RE: Request for additional information for review of Nordion F-522 package

Responses to NRC RAI in support of F-522 review

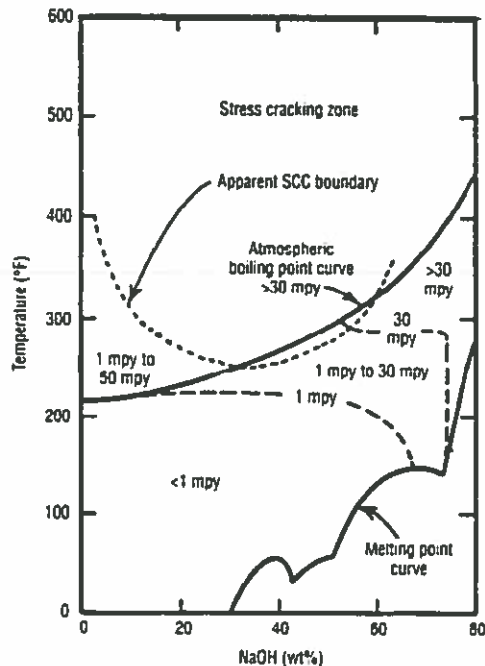
Q Mt-1. Revise package drawings to include: (i) tolerances of dimensions and (ii) material specifications of receptacles.

R Mt-1. Tolerances for critical dimensions and clarification of materials have been added to the information drawing, F652201-001. See the attached draft version of the information drawing. A final version will be provided once approved.
